## Re: TransPort Colorado Water Tank Site Plan DA-1793-14 Response to Submittal #4

We have reviewed your comments of the Transport Colorado Water Tank Site Plan and our responses to relative comments are as follows:

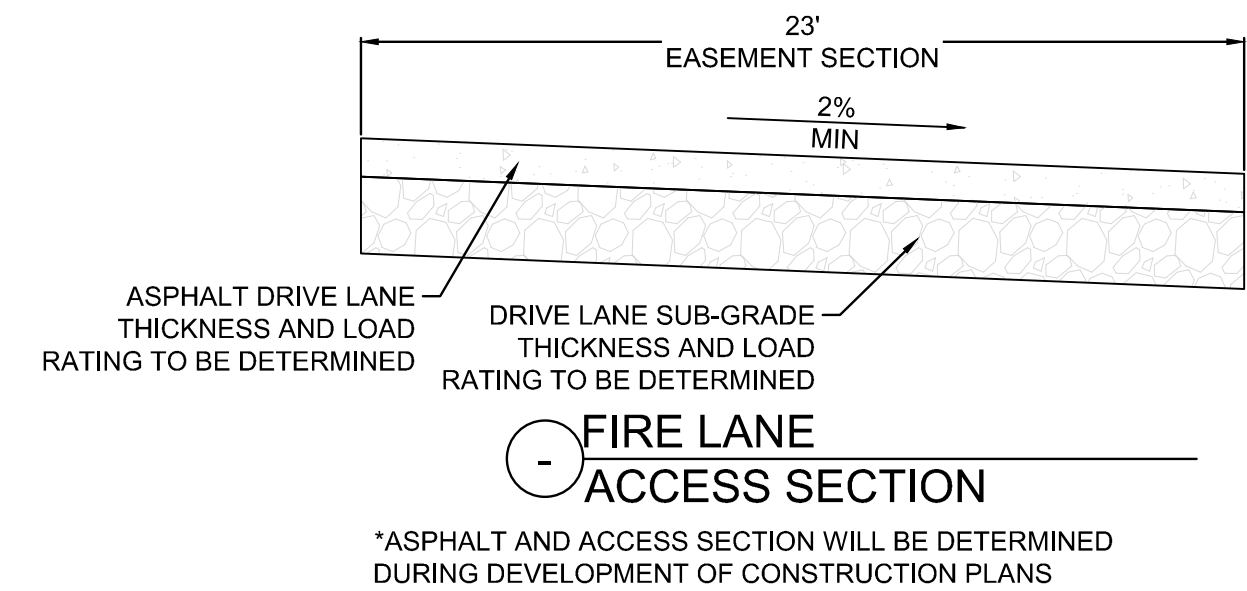
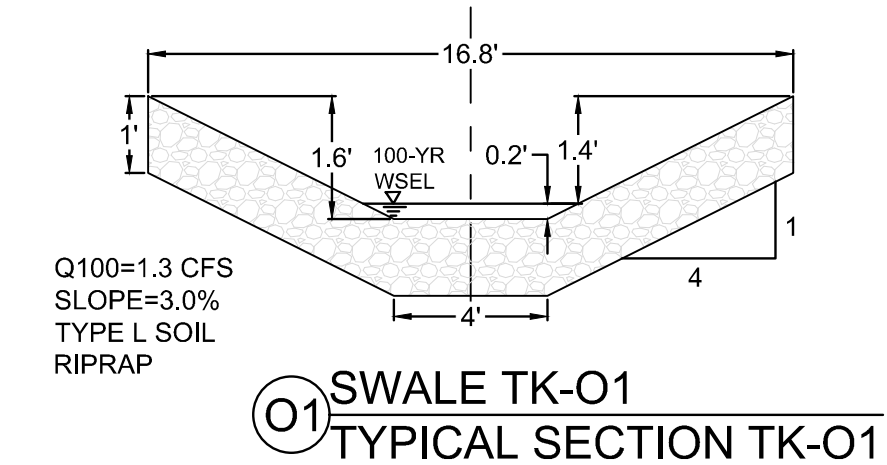
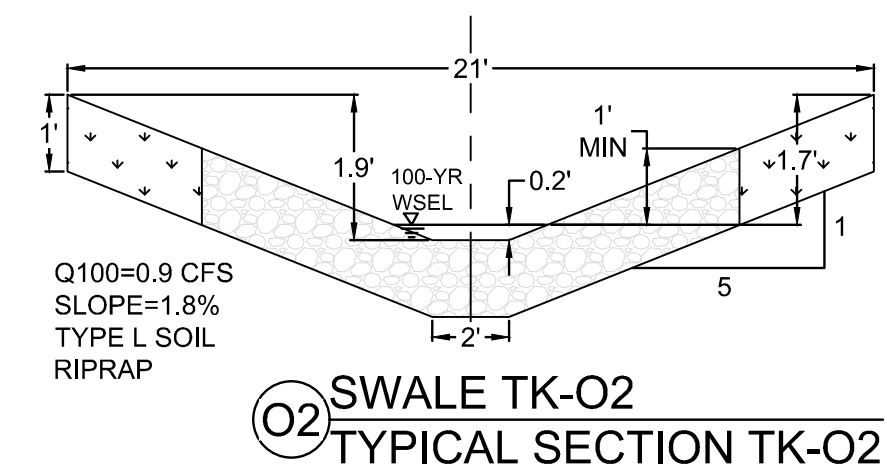
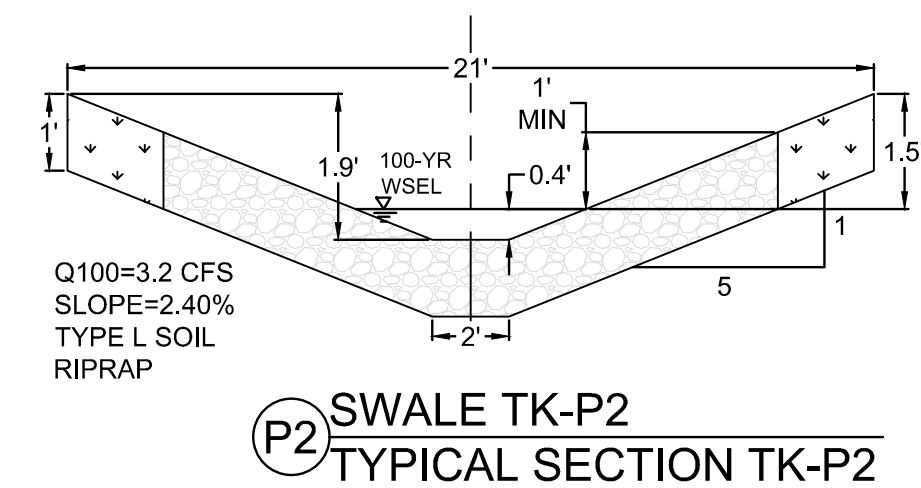
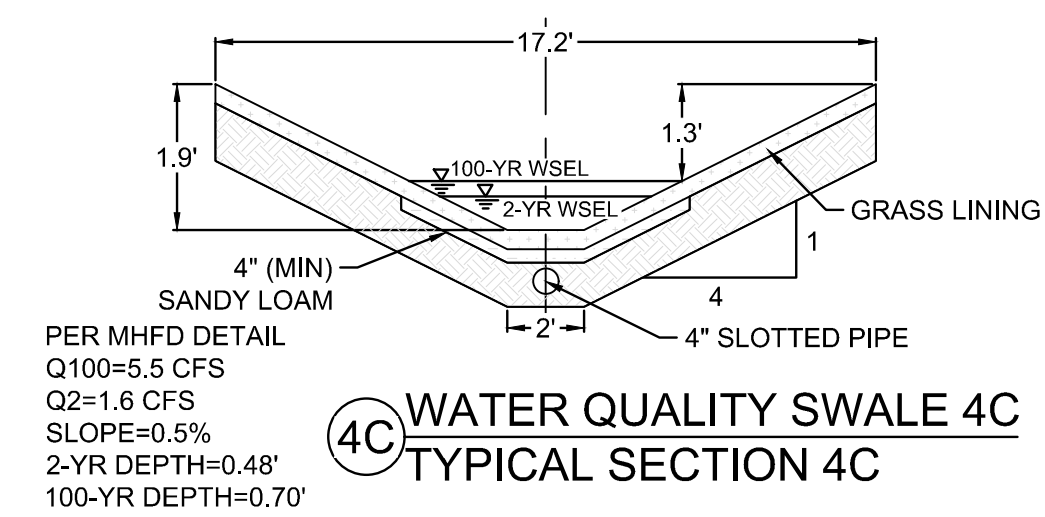
Revise the fire lane sign with the "graphic" fire lane sign. Also, a "graphic" tow-away sign must be attached below the fire lane sign., see example.

RE: Sign and graphic updated to MUTCD standard signs.

Graphic Fire Lane sign and Graphic Tow Away sign updated

A PART OF THE SOUTHEAST QUARTER OF SECTION 28, TOWNSHIP 3 SOUTH, RANGE 64 WEST OF THE 6TH P.M.,  
CITY OF AURORA, COUNTY OF ADAMS, STATE OF COLORADO  
SHEET 2 OF 3

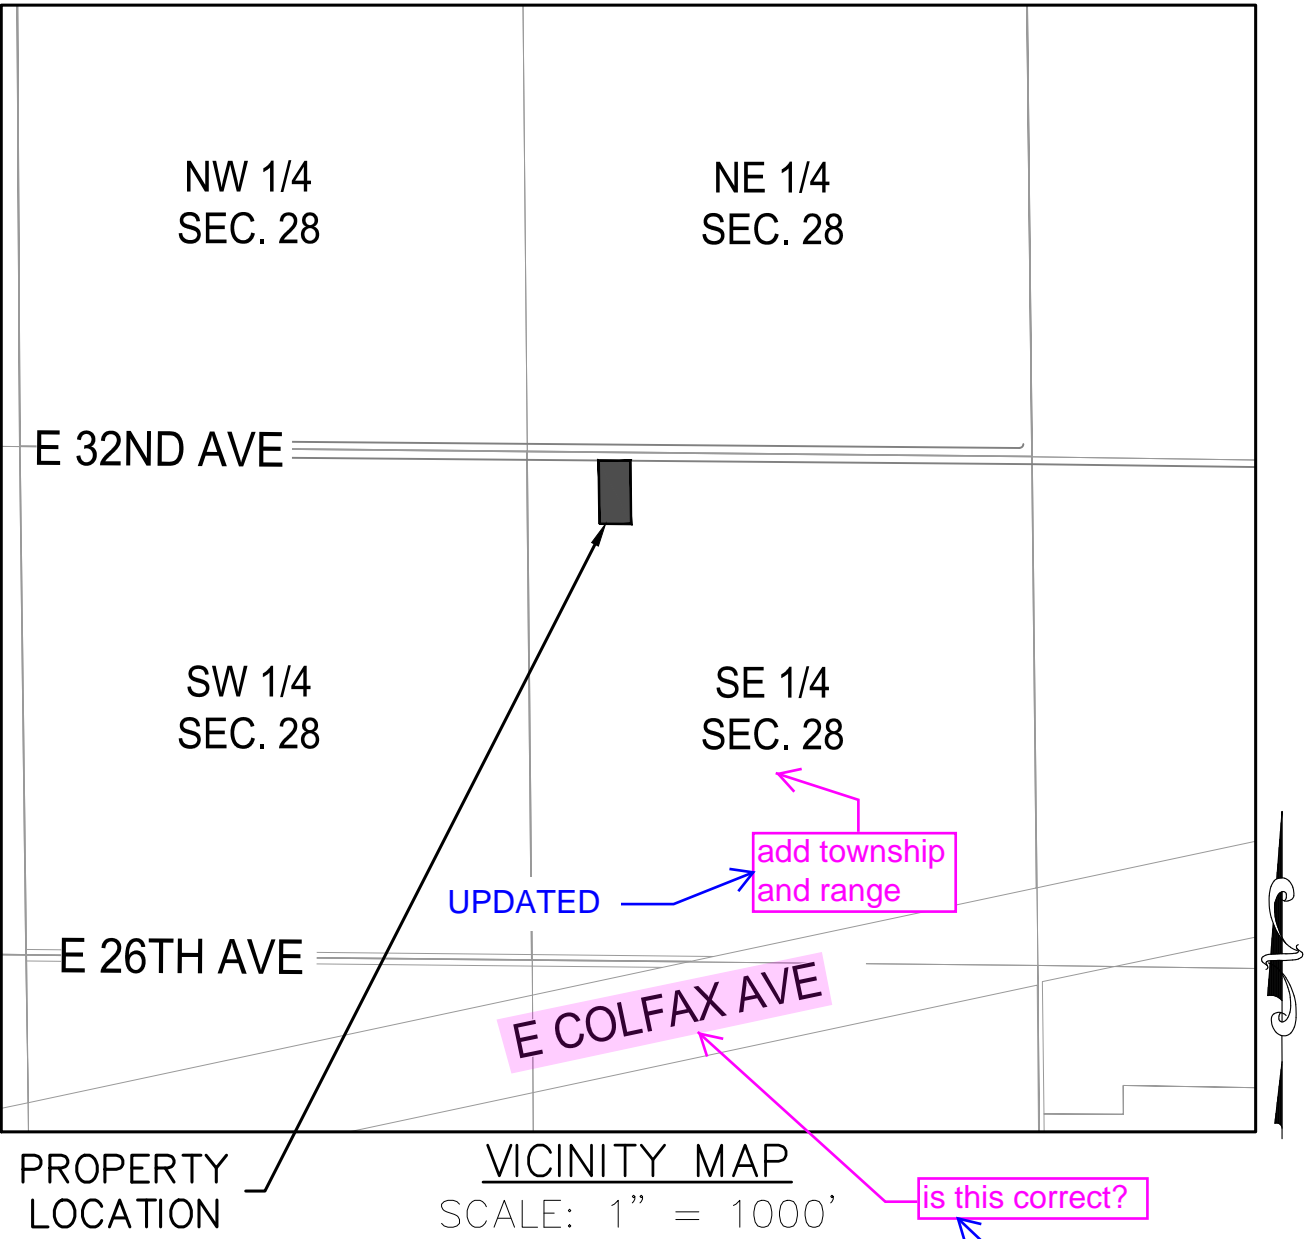
2. Composition. The basis of bearing statement shall state the method used to derive the bearing (i.e., assumed, astronomic, geodetic, grid, reference to recorded or deposited survey, etc.) and the bearing between **fully described monuments** (i.e., monument material, diameter, length (if set), cap size and material, **cap markings/stampings**, etc.) at each end of a single line. When the monuments at each end of the reference line are fully described on the plat, they need only be referenced in the "Basis of Bearings" statement.

update the Title Commitment to be within 120 calendar days of the plat approval date

UPDATED

UPDATED

ACKNOWLEDGED
